Access Compliance Report Public Rights-of-Way (Pedestrian Signals)

Main Street: **ANTONIO_PKWY** Cross Street: **SWEETWATER** Location: **E**

ADA ID: **SGRK211019115753** Signal Type: **One Push Button-APS** Overall Compliance: **No** Severity Scores: **BTN 1: 25** **BTN 2: N/A** **No BTN: N/A**

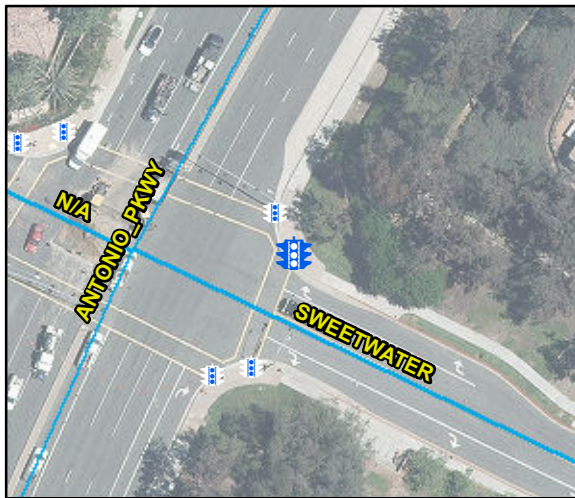
OC Std/PROW: **R404.2, R404.3**

Possible Solutions: Remove and Replace Clear Space.
